**Addendum Number:** 01

**Addendum Issue Date:** February 1, 2021

**Project Name:** CMH Ortho Clinic Addition and Renovation

**Project Number:** 0200707.00

WB - CANOPY COLUMN

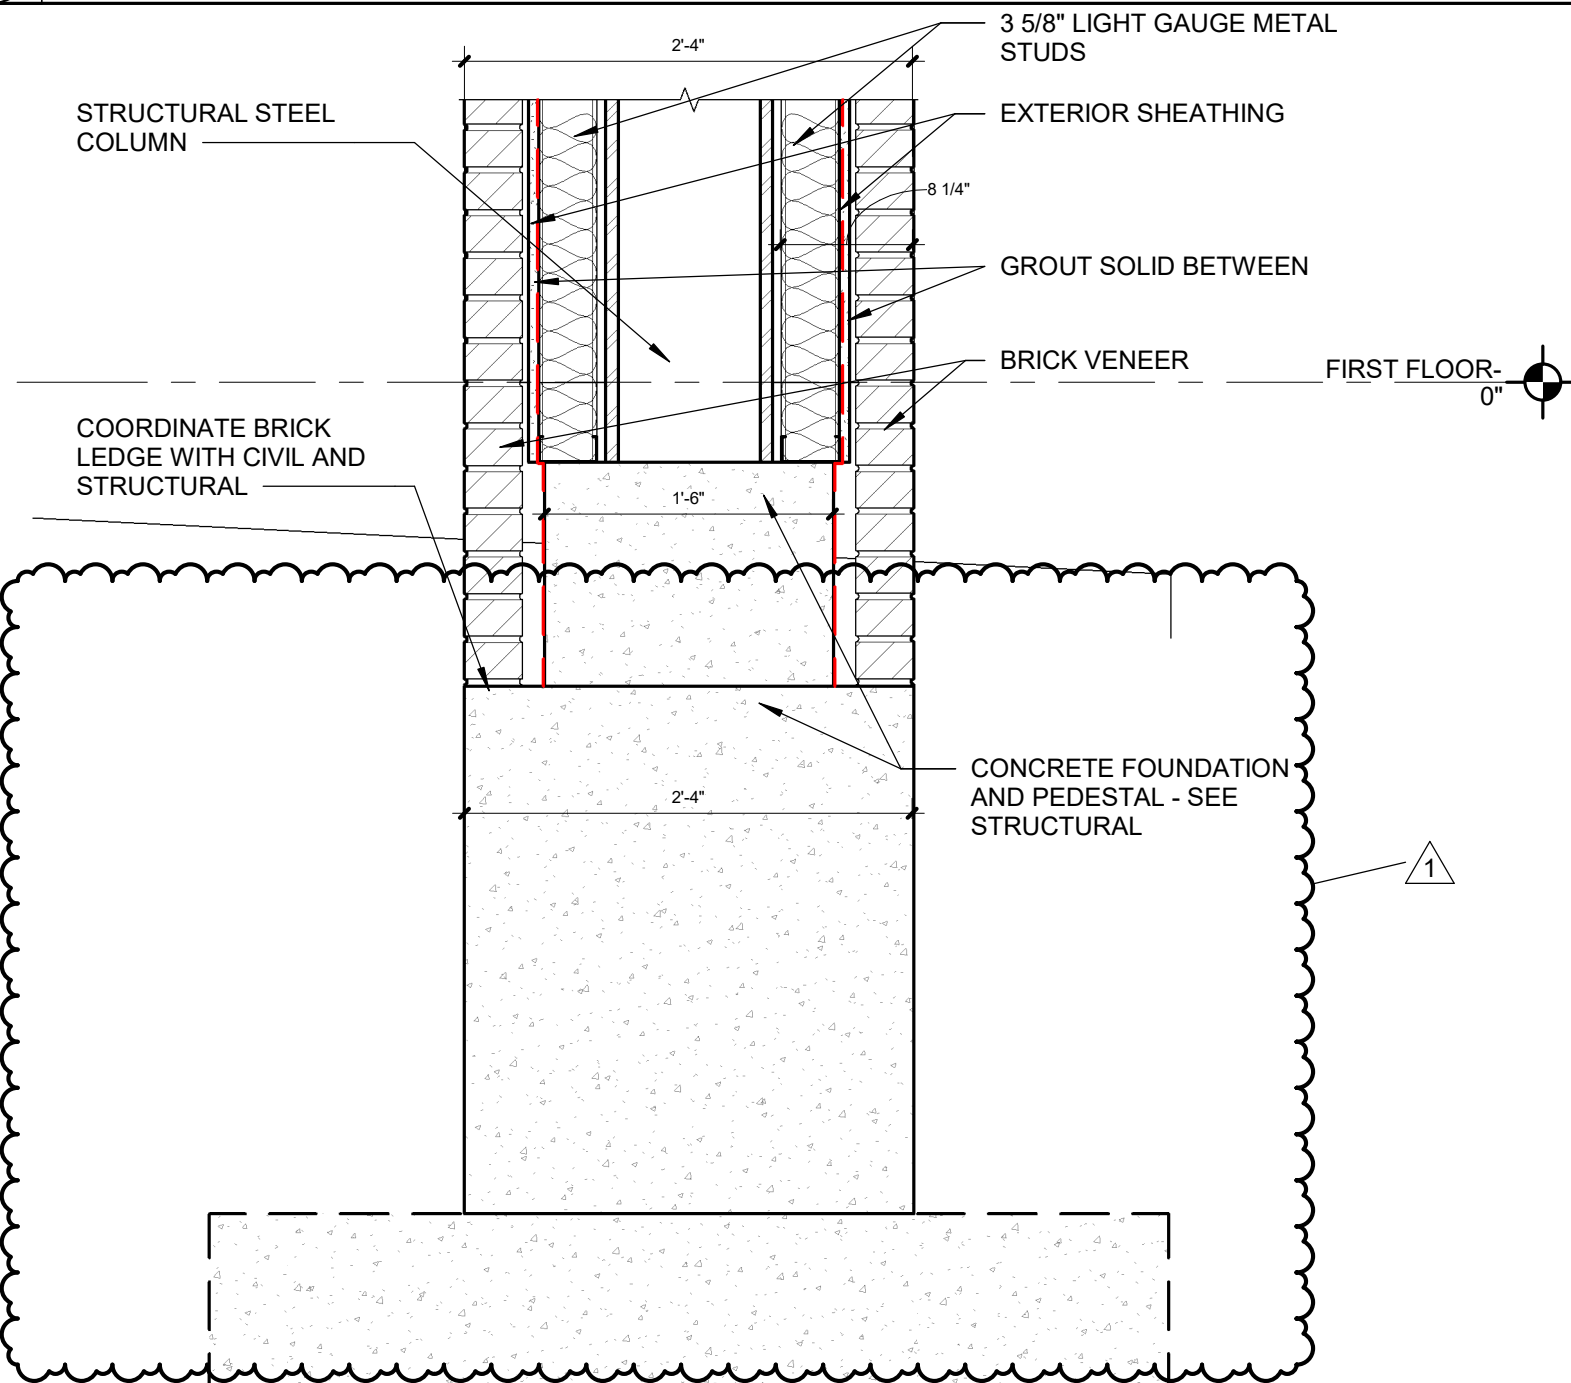
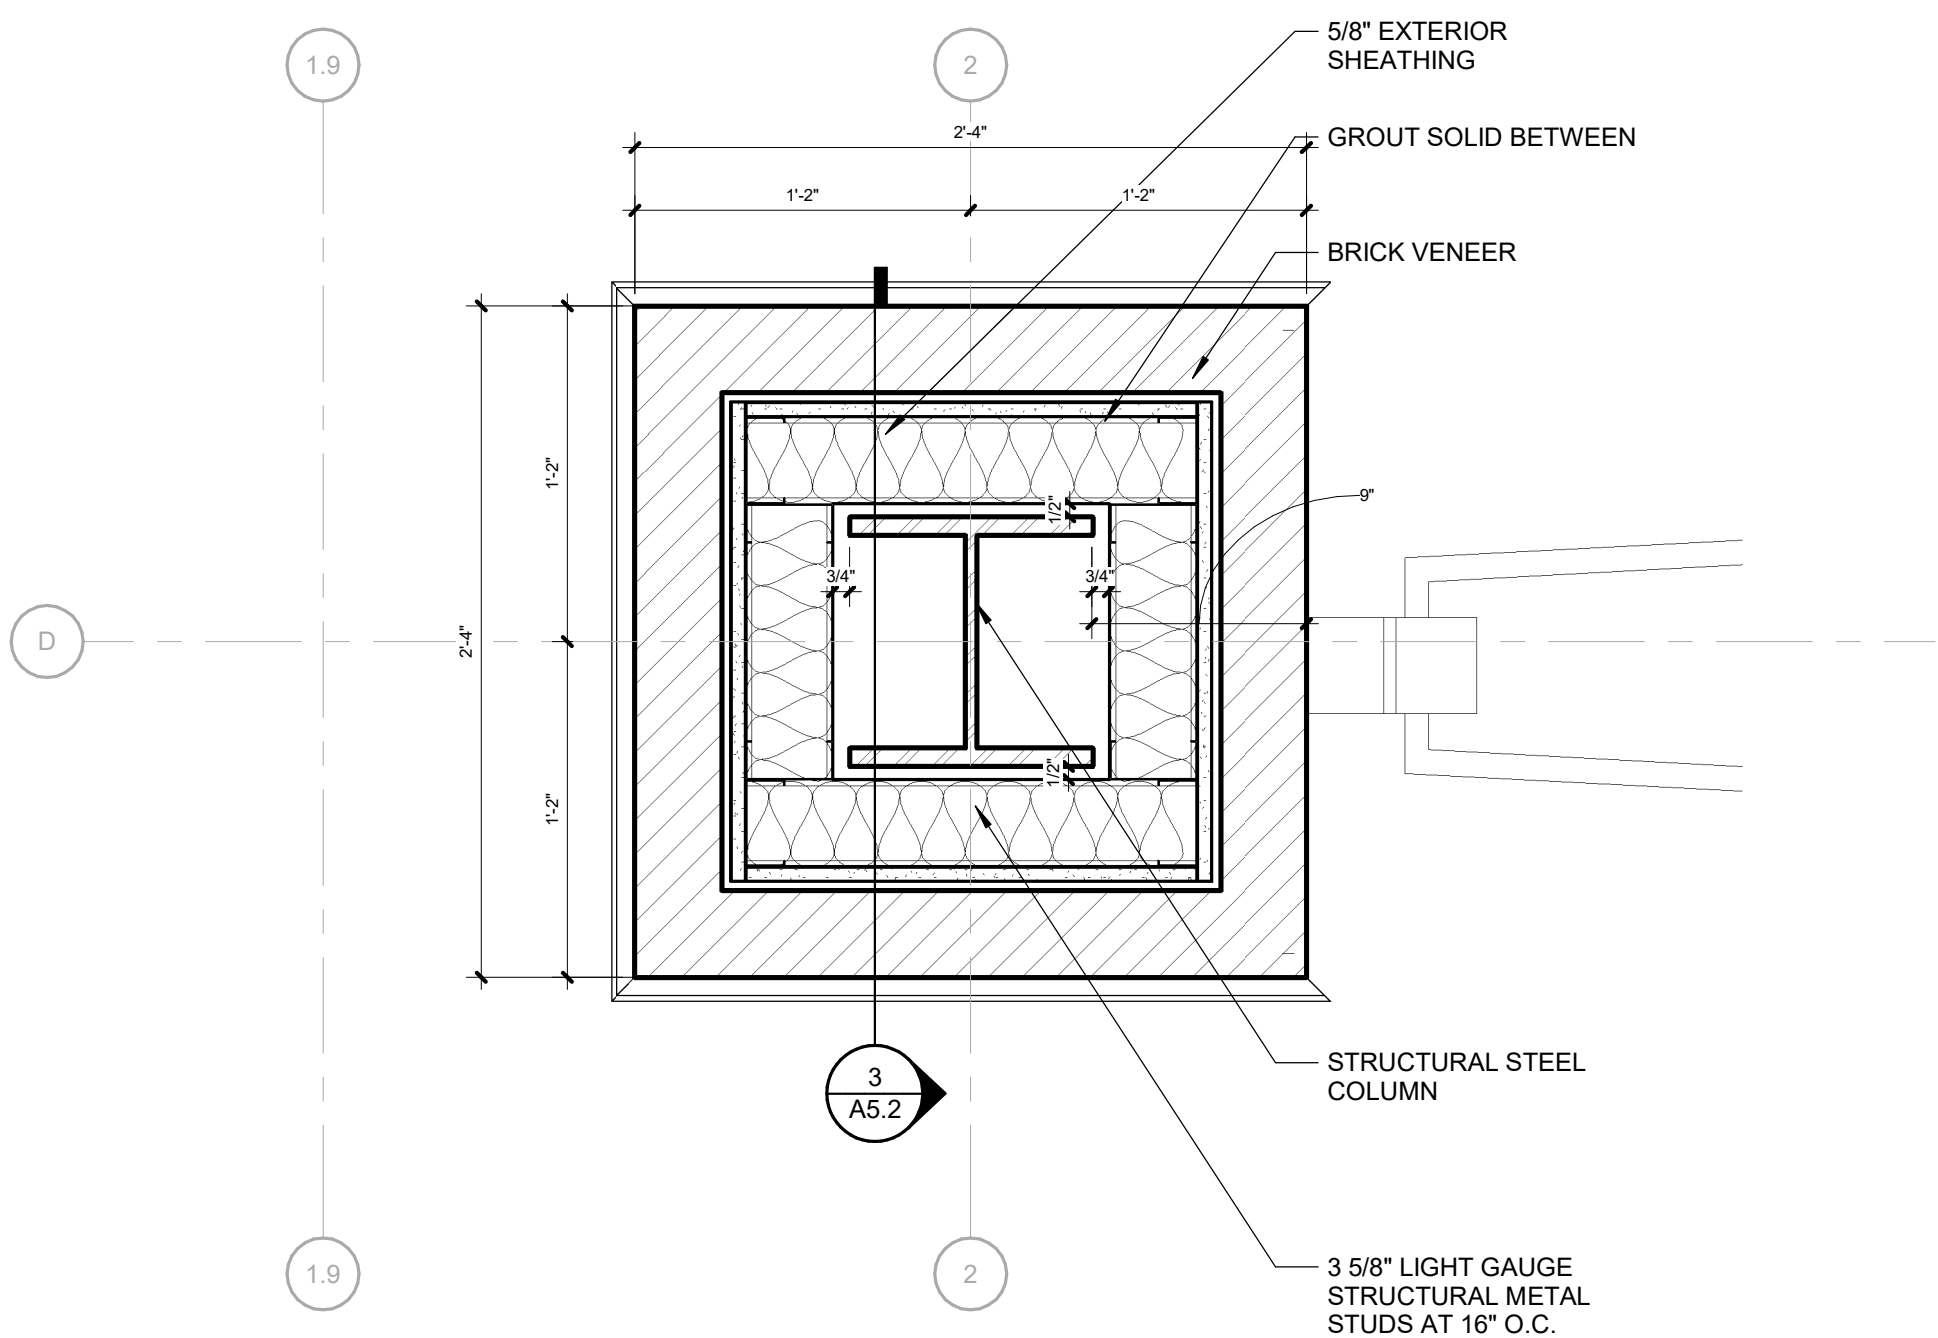
8. Sheet A5.2 – EXTERIOR DETAILS/BRICK-MTL STUD

- a. REVISE canopy column foundation detail. See the attached reissued S1.1 & S3.1 sheets for more information.

SHEET NUMBER:  
**A7.1**

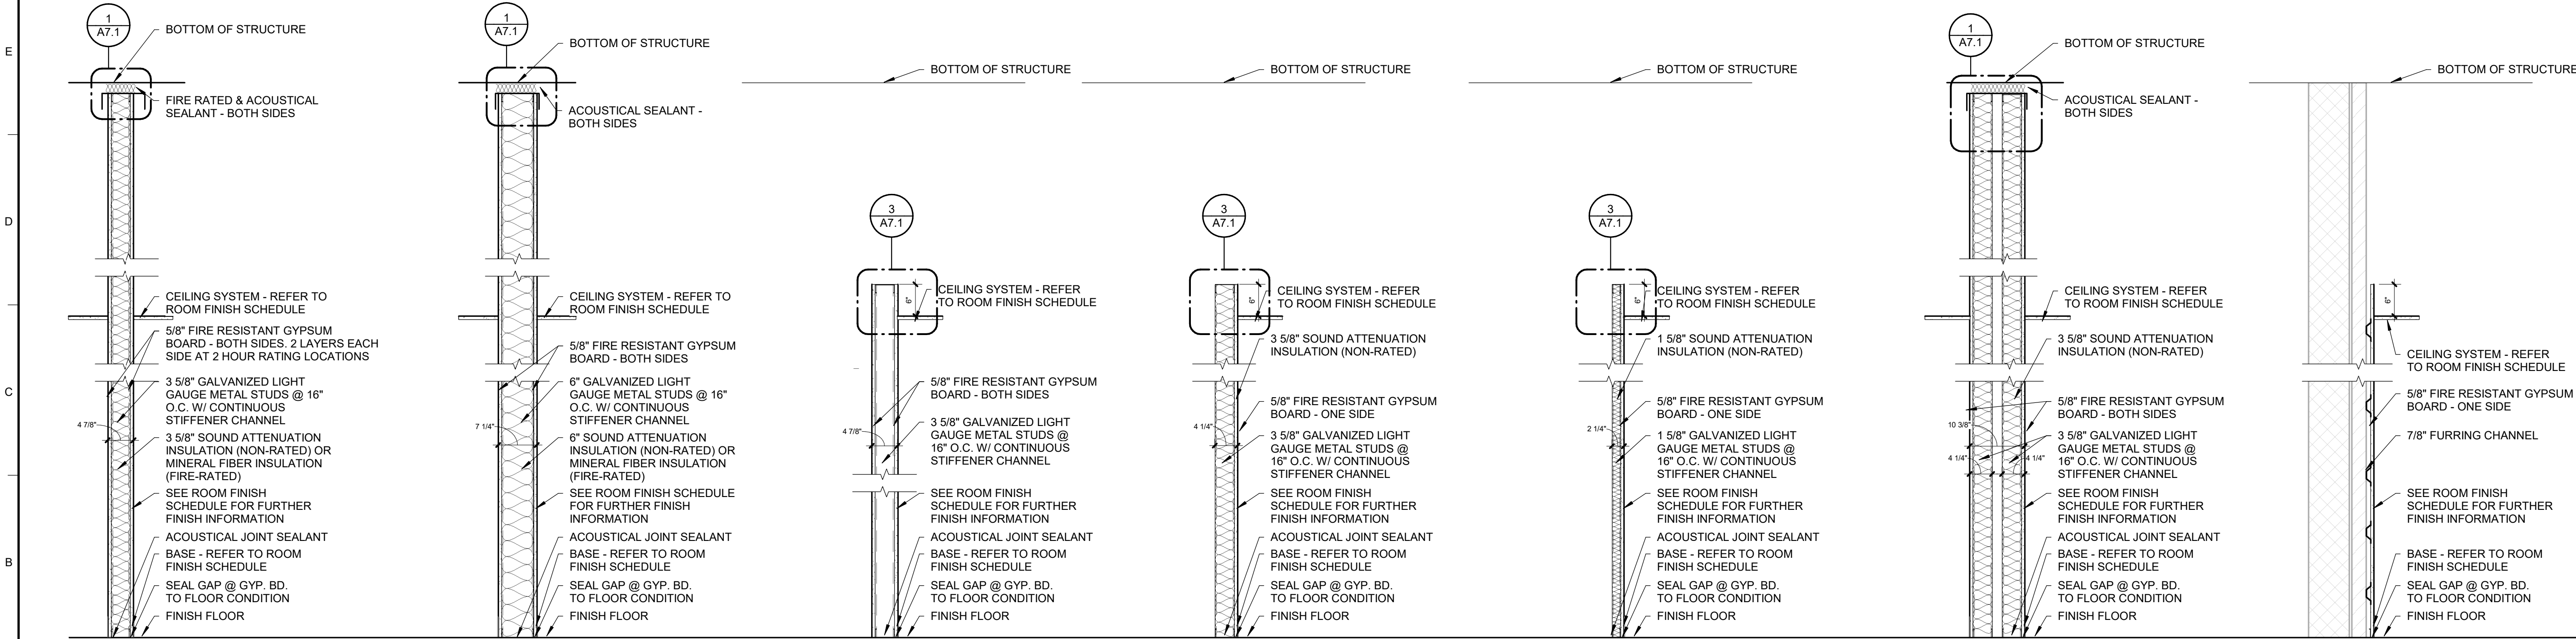
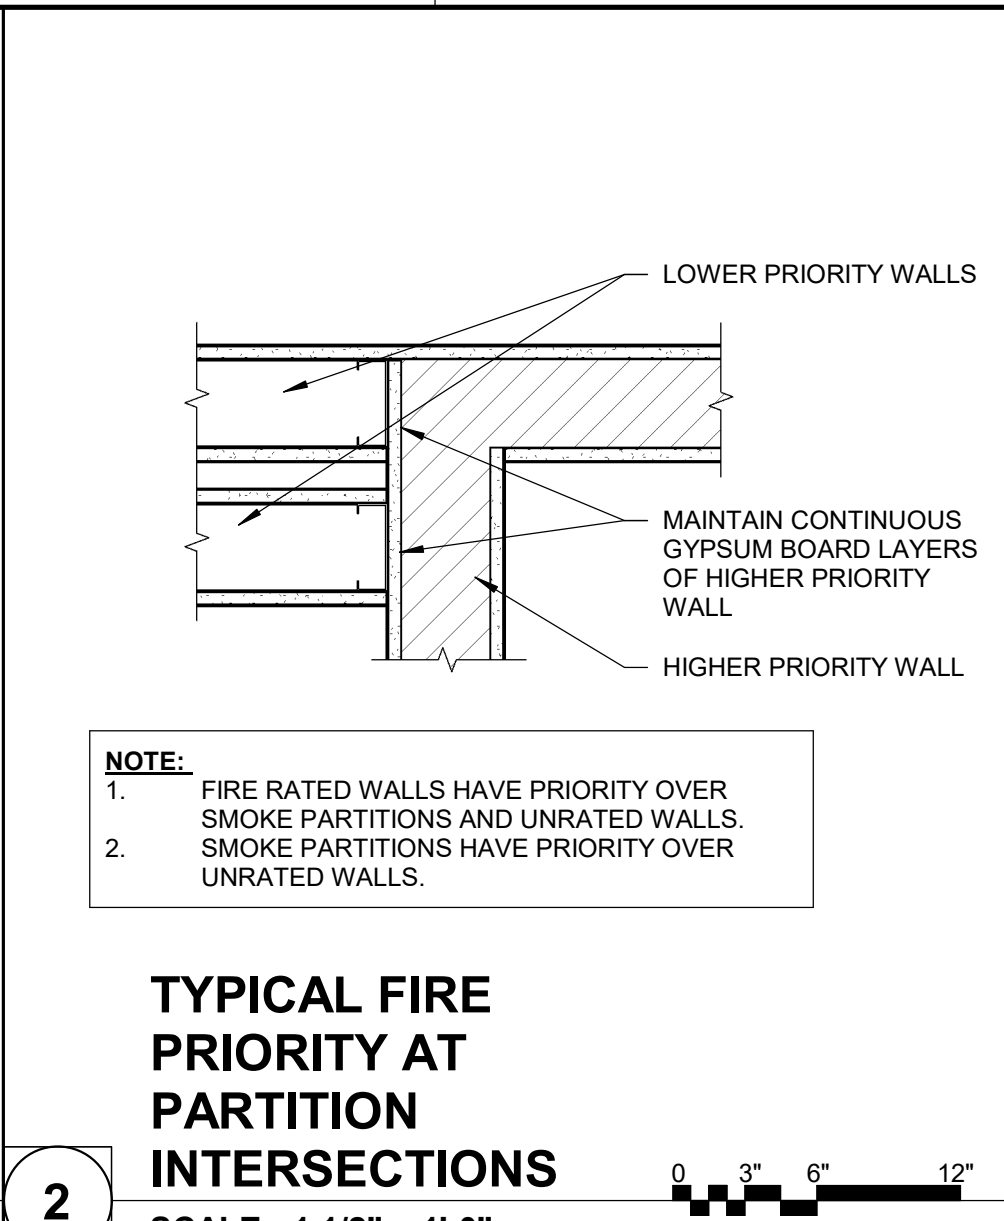
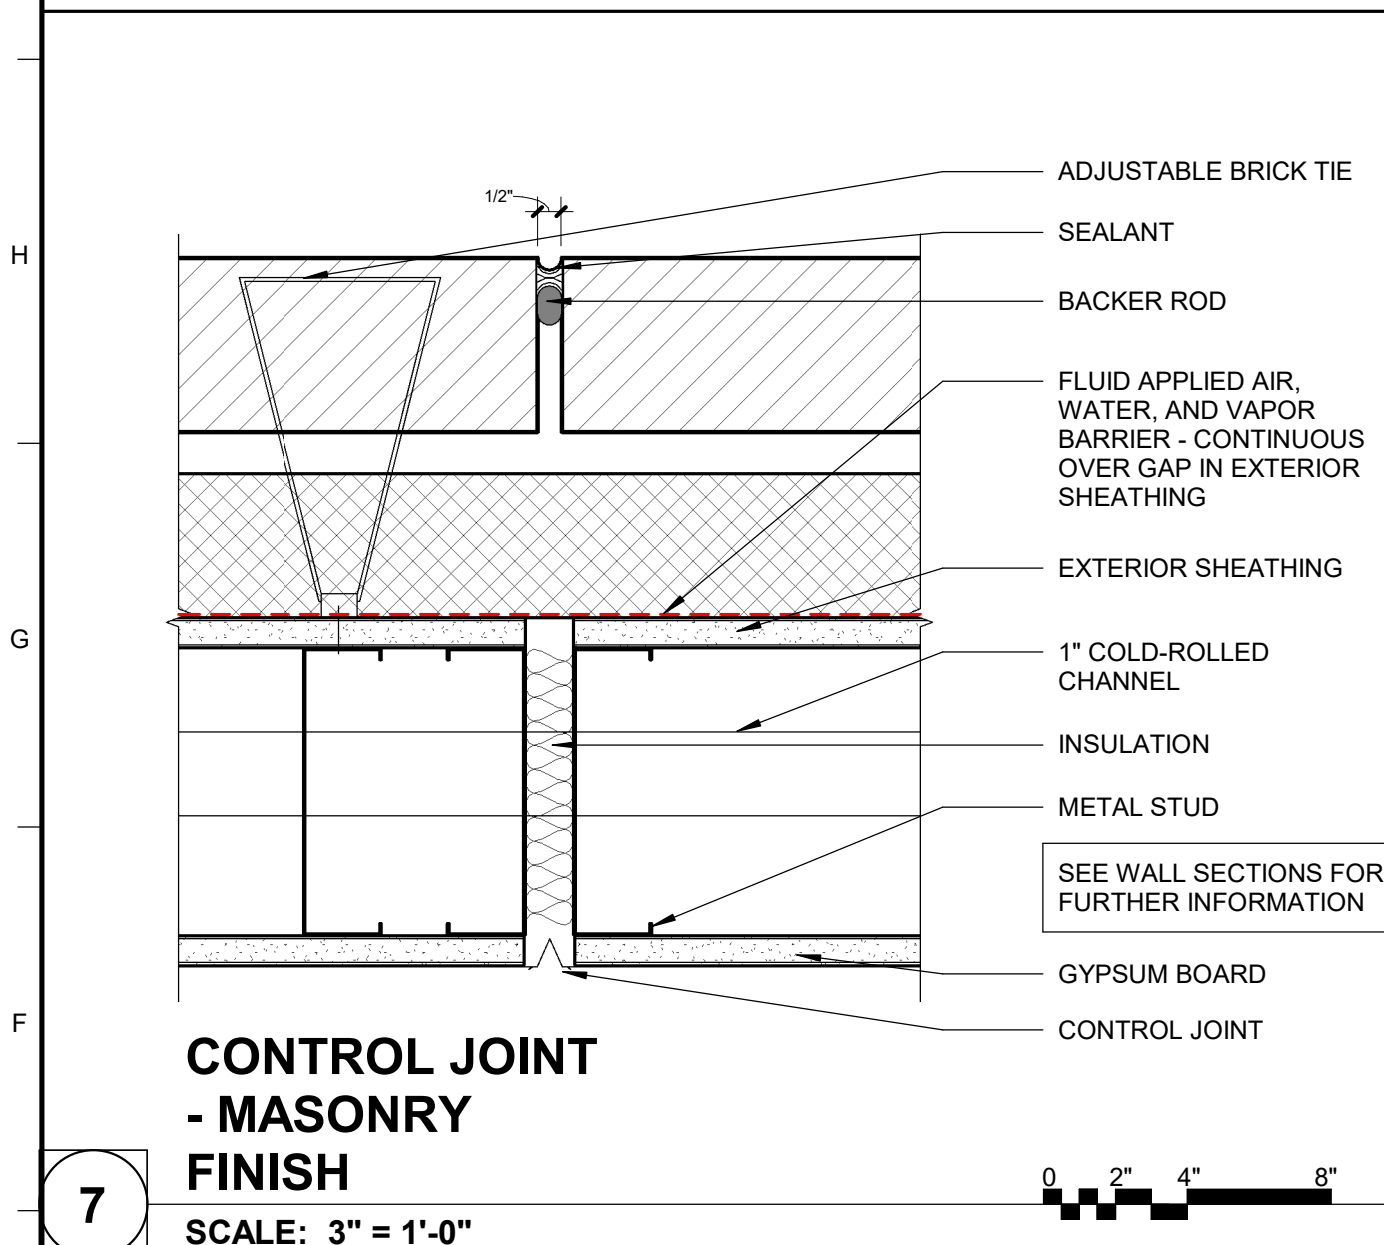
9. Sheet A7.1 – PARTITION TYPES

- a. ADD general note N to include all gypsum board to be mold resistant type. See the attached reissued sheet.

- ALL GYPSUM BOARD TO BE MOLD RESISTANT TYPE.
